DUKE POWER COMPANY
OCONEE NUCLEAR STATION

Attachment 1
Proposed Technical Specifications

TABLE 4.4-1
LIST OF PENETRATIONS WITH 10CFR50,
APPENDIX J TEST REQUIREMENTS

Attachment 4
Technical Justification

FIGURE 1
INITIAL CONFIGURATION

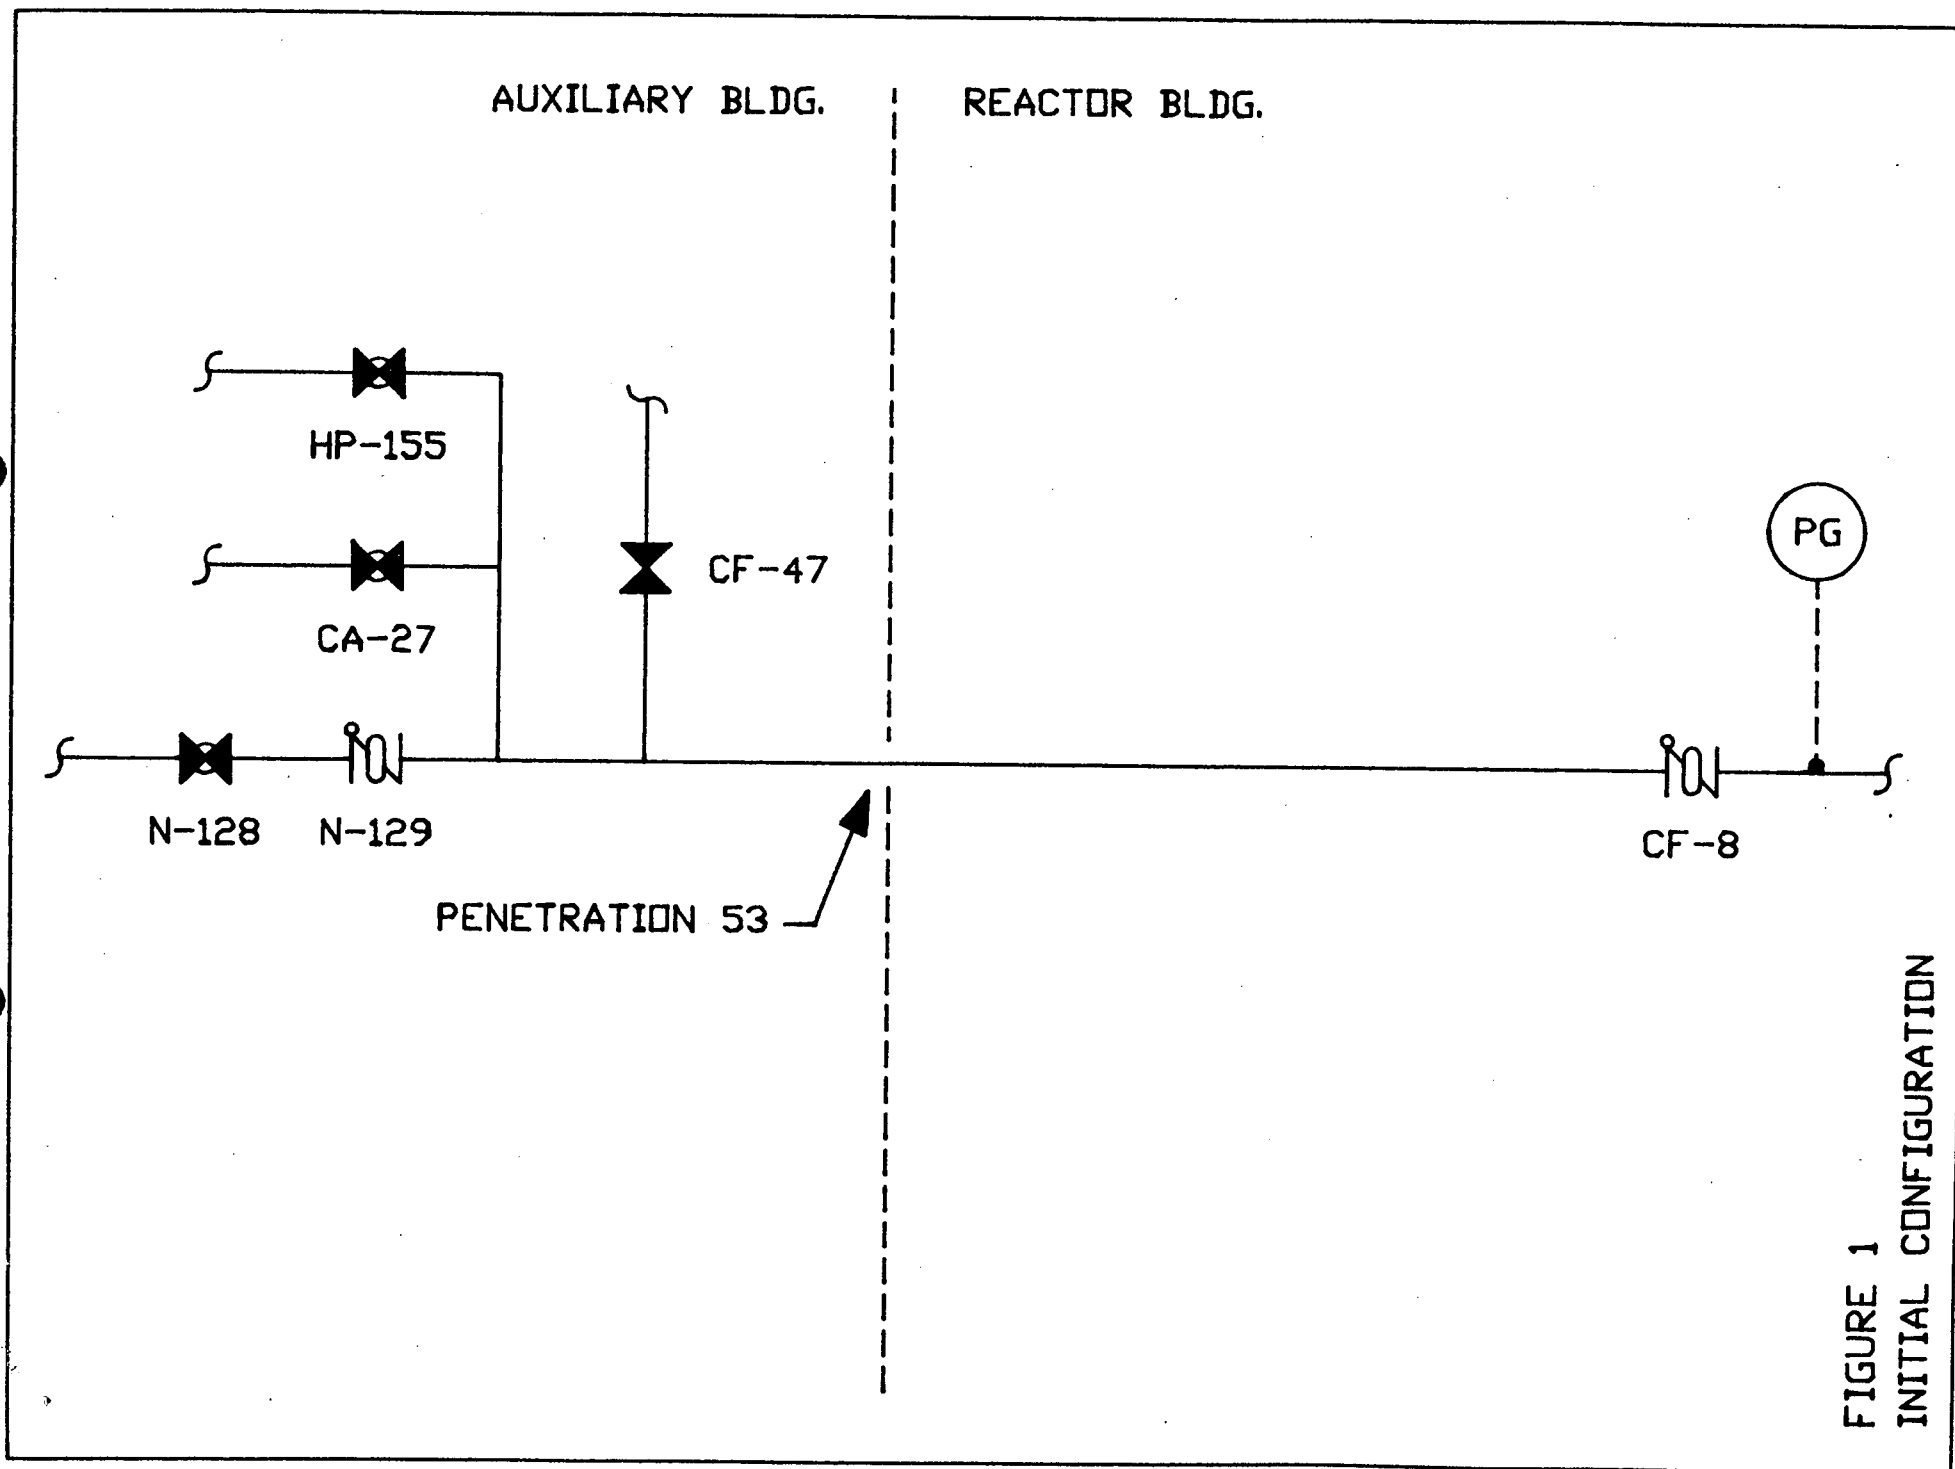
Figure 1 provides the initial configuration of Penetration 53. This penetration consisted of an inside isolation check valve (CF-8) and outside isolation valves (N-129, CA-27, HP-155 and CF-47) along with connecting piping. Technical Specification in affect at that time did not require a type C test for this penetration, thus none was performed. During a type A Integrated Leak Rate Test (ILRT), penetration 53 was properly challenged during the type A test.

FIGURE 2
1982 MODIFIED CONFIGURATION

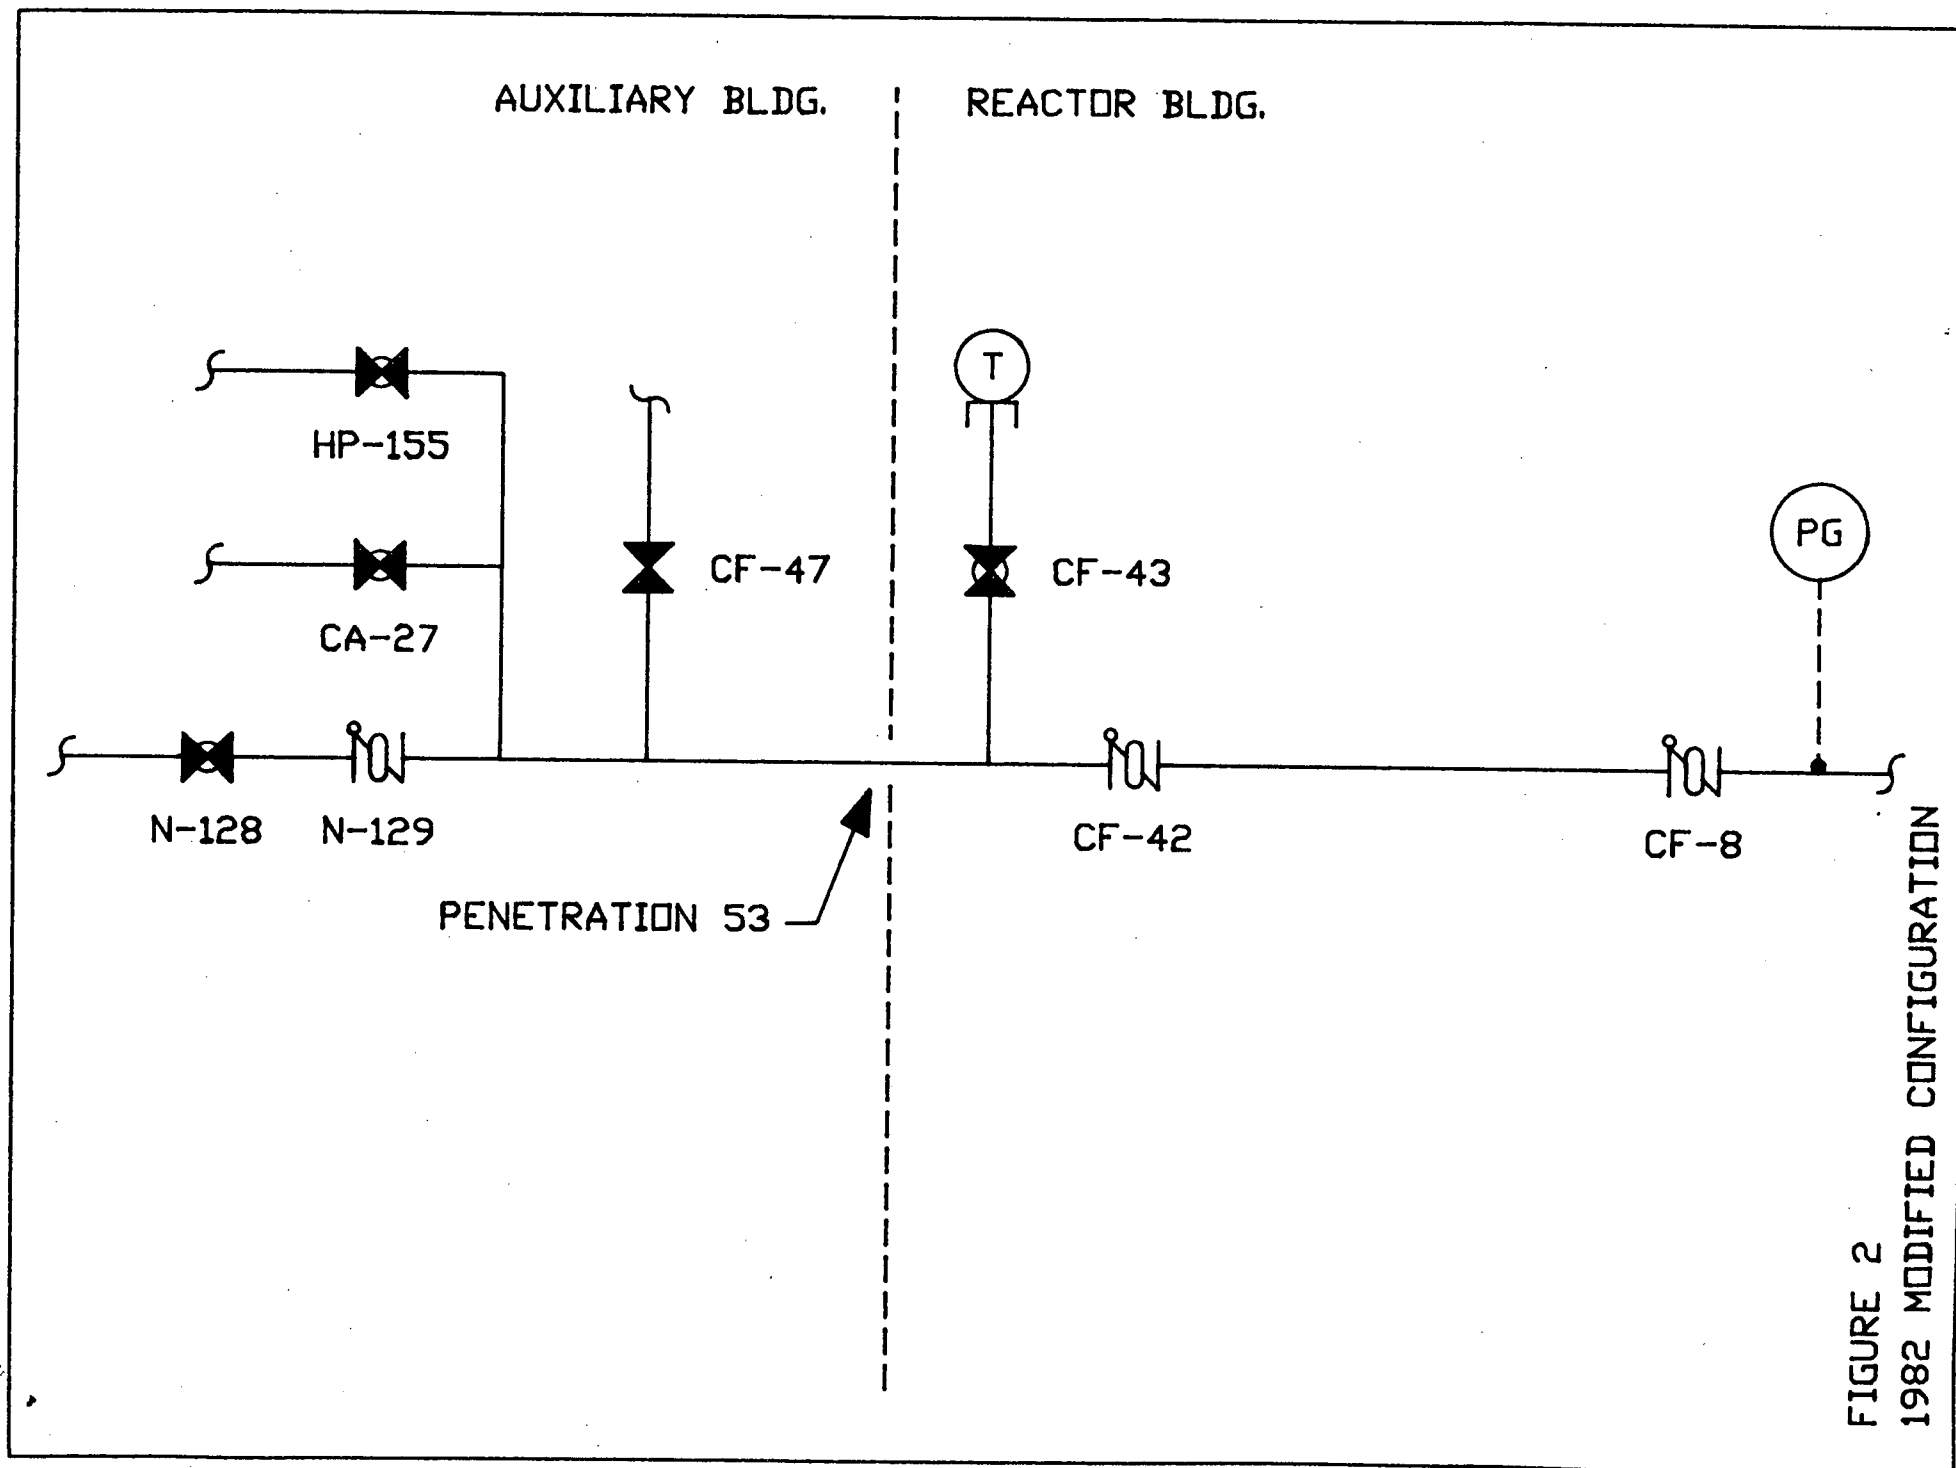
In 1982, penetration 53 was modified to add valve CF-42 and vent valve CF-43, as shown in Figure 2. These two valves (CF-42 and CF-43) were added to address a seismic qualification concern associated with the piping from the containment wall to valve CF-8. With this modification the new inside containment isolation valve for penetration 53 became CF-42. After Unit 3 was modified, a ILRT was conducted in 1982. During this test valve 3CF-43 was opened and the piping was drained of fluid. This, in effect, challenged the outside containment isolation valves. This test complied with technical specification surveillance requirements. Subsequent tests for Unit 3 and all tests for units 1 and 2 were performed without opening valve CF-43. As such the penetration was not tested properly. These type A tests, in effect, only challenged valve CF-8, but did not challenge the actual containment penetration valves.

A special test to qualitatively assess the potential leakage through penetration 53 on unit 2 was performed on September 28, 1989. Utilizing nitrogen pressure trapped within the penetration boundaries from previous nitrogen additions to the A core flood tank, leakage through 2N-129 was found to be no more than 0.53 lbm/hr. Utilizing nitrogen pressure in the A core flood tank, leakage through 2CF-8 and then through 2CF-42 (see figure 2) was found to be below detectable levels.

FIGURE 3
1989 MODIFIED CONFIGURATION

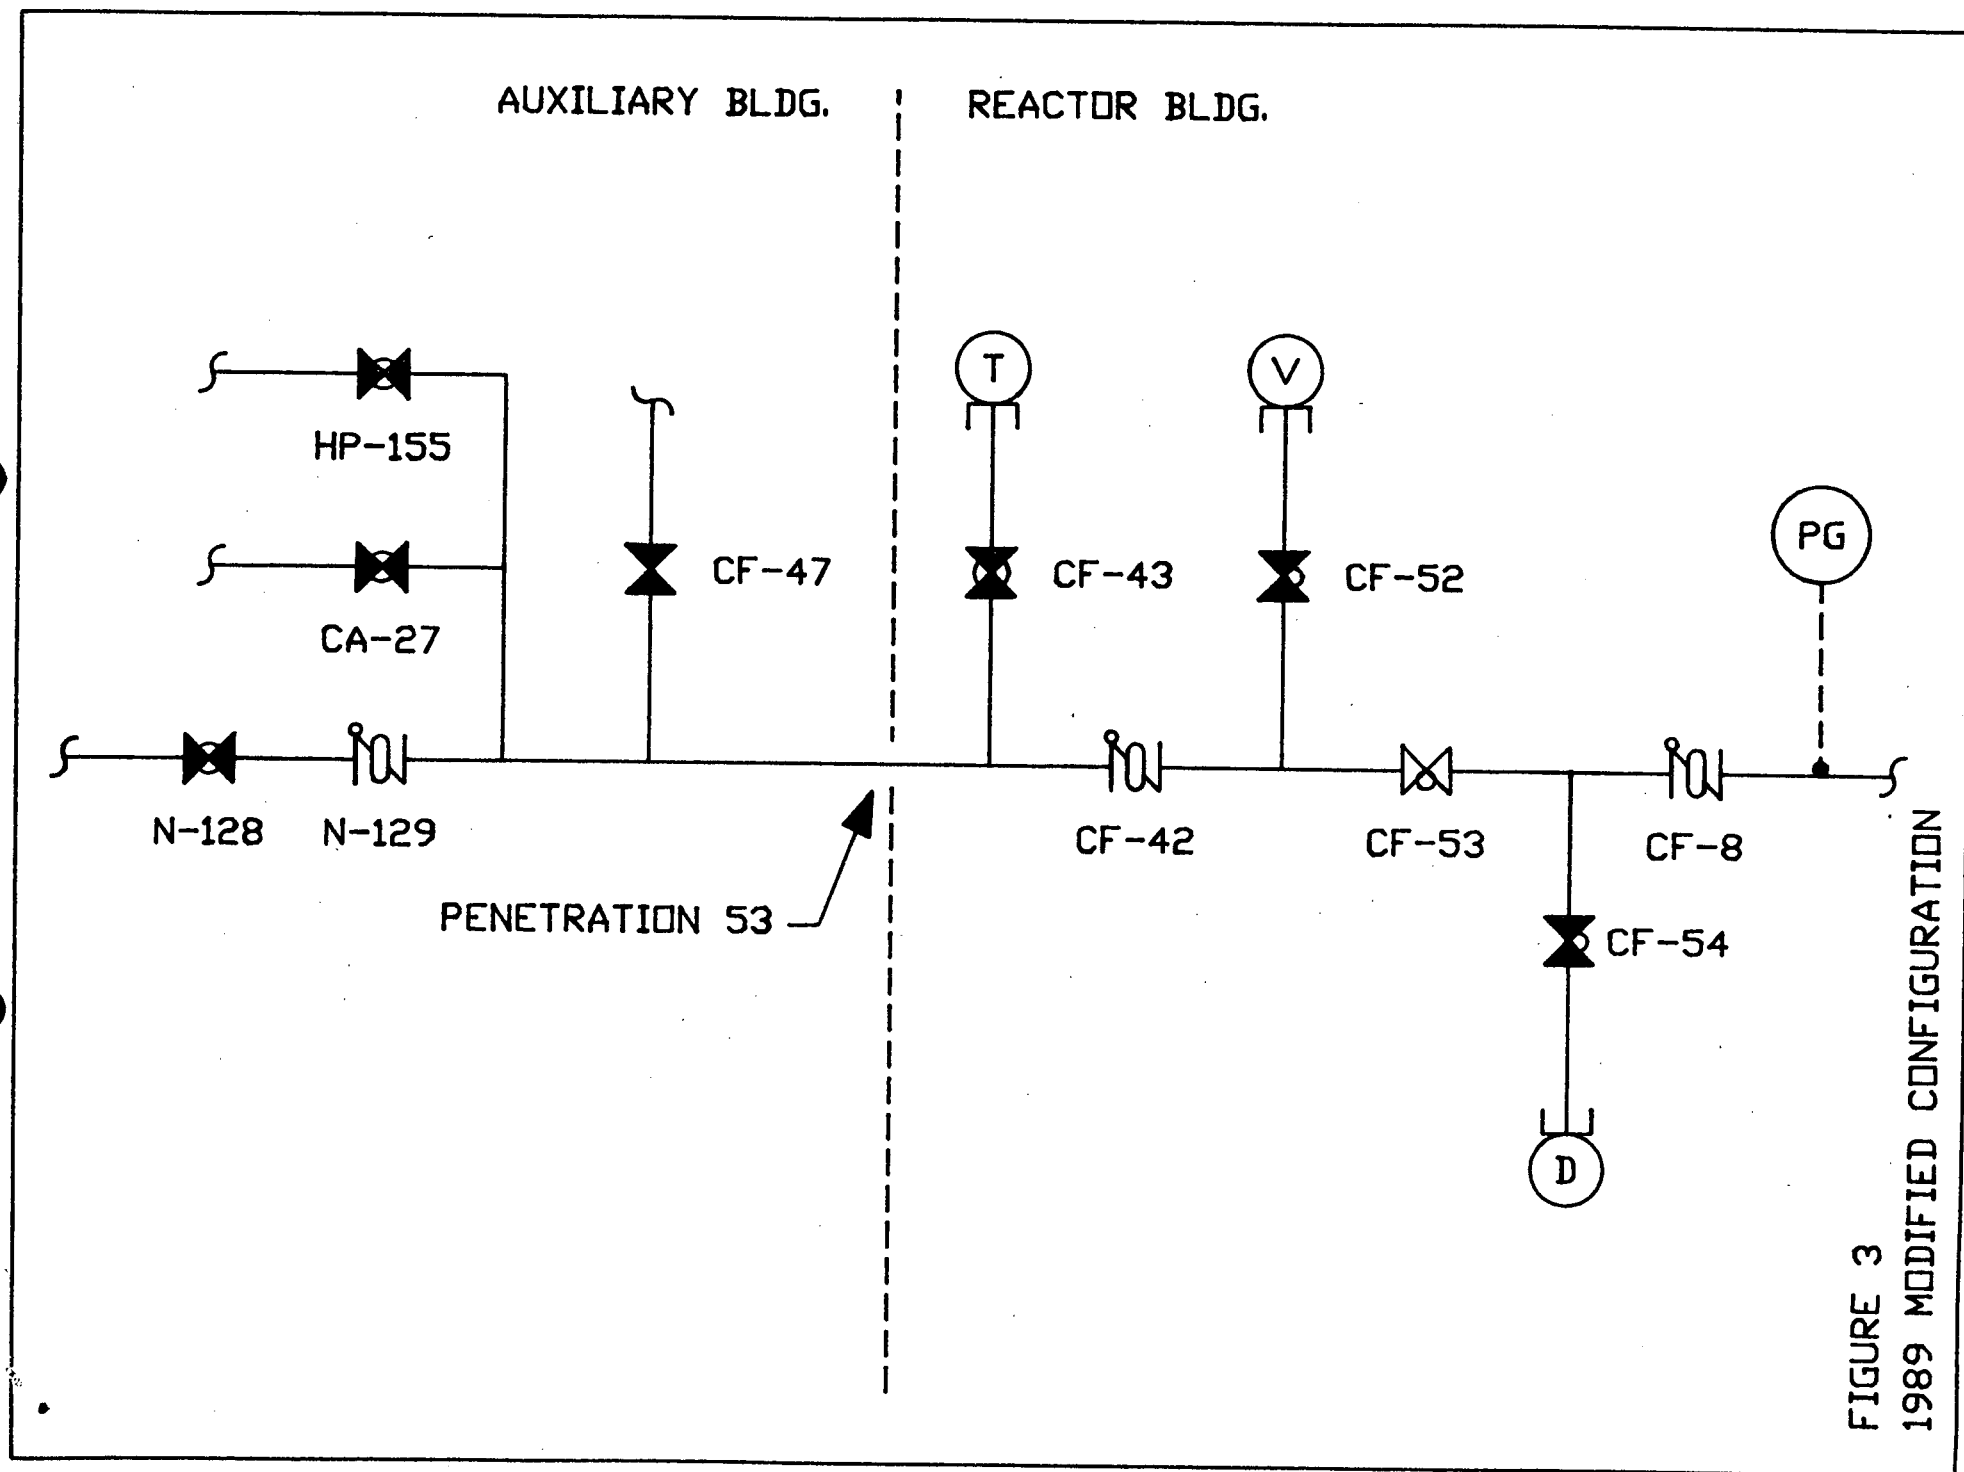
To resolve the above concern, the configuration for penetration 53 is being modified (Figure 3). The modification will add a vent valve, a drain valve and a test isolation valve to the Nitrogen line that feeds the A core flood tank. The new vent and drain line and test isolation valve will allow local leak testing of CF-42 and simplify type A testing of the penetration. During future ILRT, the new vent line will be open to the containment atmosphere.

The modification affects the non-seismic portion of the Nitrogen System. The piping is non-QA and non-safety related. The new vent and drain lines and the new valves are designed for the connecting piping's design temperature and pressure. The vent and drain valves will be normally closed and the vent and drain line will have pipe caps installed. The new valve installed in the main nitrogen line will be kept normally open. The stress analysis for the piping changes were reviewed and determined to require no support changes. These changes will not affect the safety related portion of the Nitrogen System. Technical specification 3.3 requires the core flood tanks to have a pressure of 600 ± 25 psig. This modification will not adversely affect this pressure requirement.
